# TRUCK UTILITY MEDIUM (HS) HT W/VPK

### MODIFICATION INSTRUCTION No. 6

**SUBJECT:** Fitment of upgraded anti roll bar and bracket

1 This modification introduces a new anti roll bar and bracket to improve specification on all SNATCH 2 vehicle variants.

Fig 1.

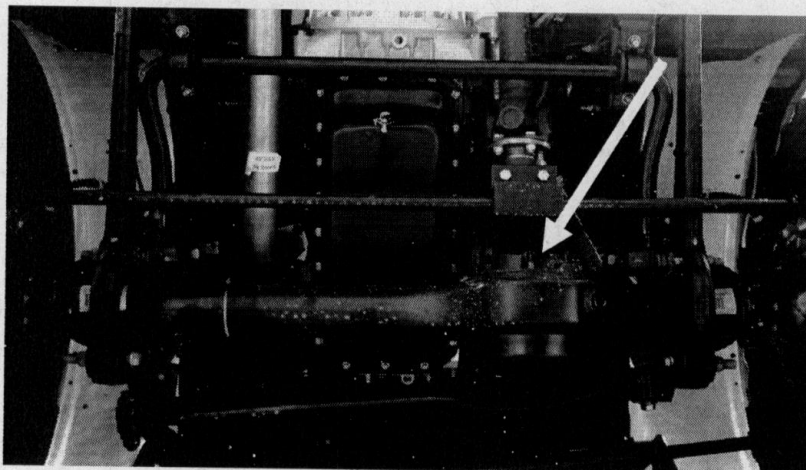
- 9.1 Stop the vehicle and turn off the ignition, apply the handbrake and place wheel chocks.
- 9.2 Disconnect the vehicle battery negative terminal.
- 9.3 Working underneath the vehicle, remove the 2 bolts that locate the steering arm guard and remove the guard, see fig 1.

Fig 2.

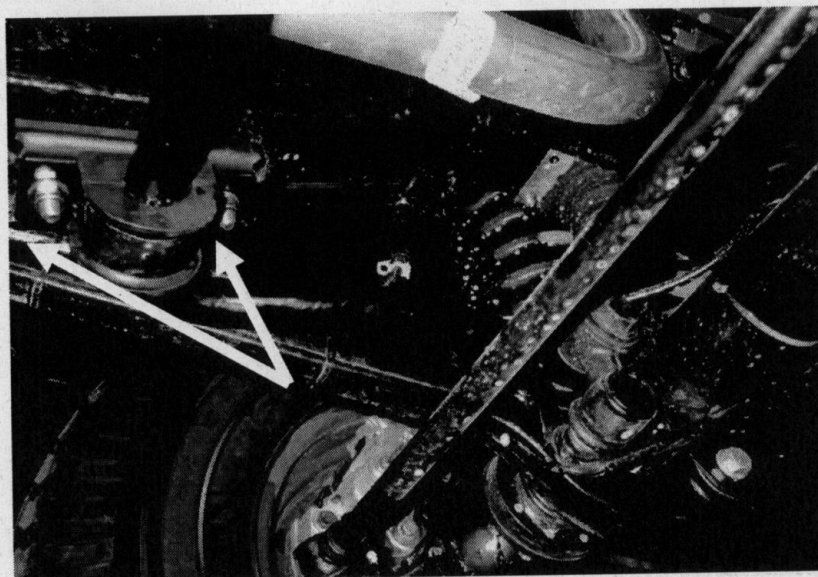
- 9.4 Remove left hand track rod end using tool (item 11), turn the track rod around the ball joint to the right swivel and secure it safely away from the work area.
- 9.5 Remove 2 X M10 nuts and washers from Anti Roll Bar bush brackets on each side, see fig 2. Remove both brackets.

Fig 3.

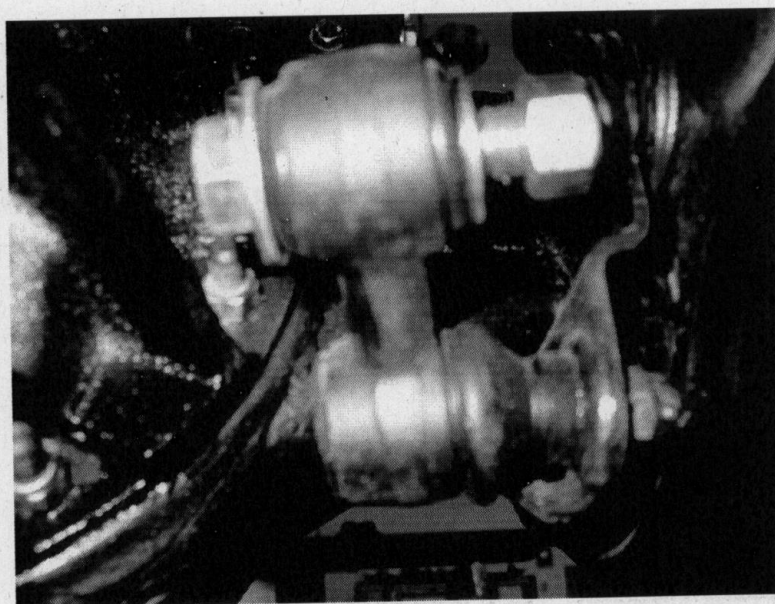
- 9.6 Pull roll bar rearwards to allow access to front fixings.
- 9.7 Remove the two nuts from the front ends of the roll bar.
- 9.8 Push the bolts through sufficiently to free the end of the anti roll bar, remove the anti roll bar.
- 9.9 Remove the split pin and bolt from the drop link on each side of the vehicle, see fig 3.

Fig 4.

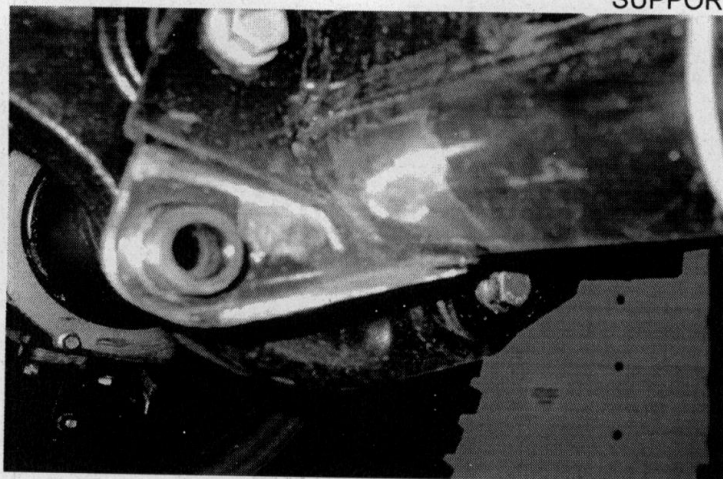
- 9.10 Remove the drop links.
- 9.11 Remove the front axle breather from the retaining clips.
- 9.12 Remove the front axle breather.
- 9.13 Clean, sand edges of brackets (items 1 & 2) to ensure good clean surface to weld.
- 9.14 Clean/sand area where the brackets are to be welded on the axle, see fig 4.

Fig 5.

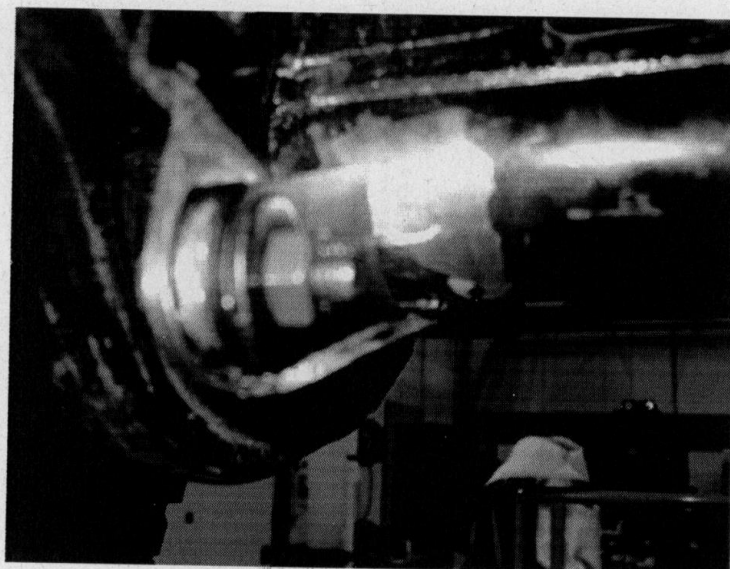
9.15 Use a locator M12 bolt, nut and two penny washers, bolt the bracket to the axle ensuring that it is located straight, see fig 5.

Fig 6.

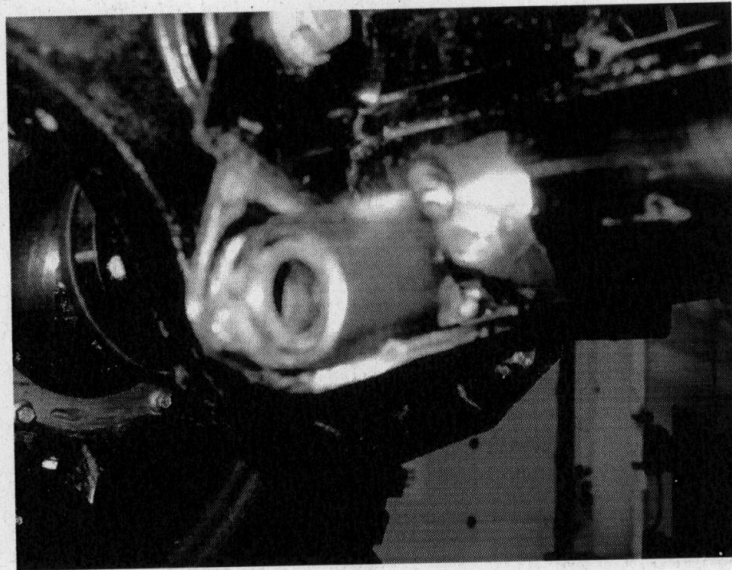
9.16 Tack the three main contact points as shown in fig 6.

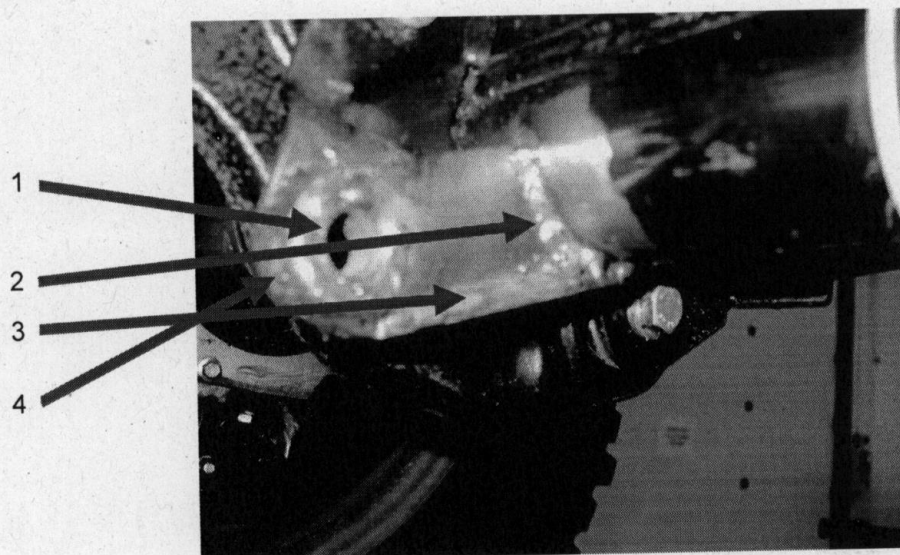
9.17 Remove the locator bolt and washer, then continue to weld the bracket using item 12 as indicated below:

9.17.1 Starting around the hole as indicated in fig 7 point 1.

9.17.2 Weld the axle edge and over the top of the bracket as indicated in fig 7 point 2.

9.17.3 Bottom of bracket as indicated in fig 7 point 3.

9.17.4 Round the front of the bracket and the boss as indicated in fig 7 point 4.

Fig 8

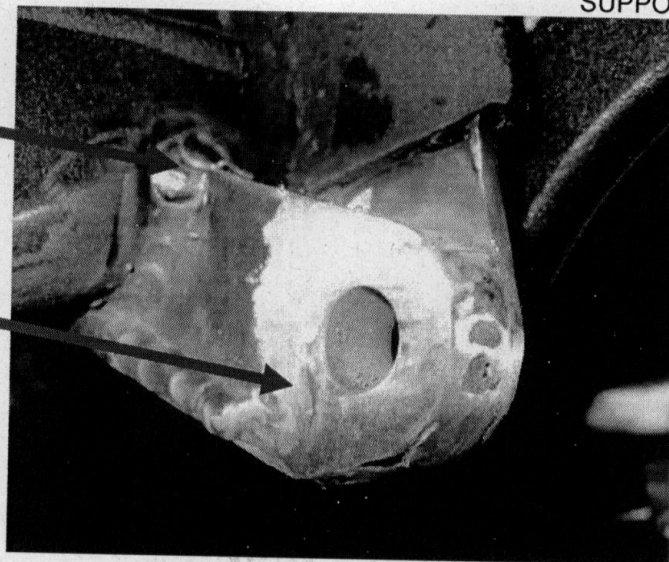
9.18 Dress back the excess weld, clean and coat with anti-rust paint, see fig 8.

**IMPORTANT  
CHECK WELDING  
OVER THE TOP OF  
THE BRACKET**

Use angle  
grinder for face.
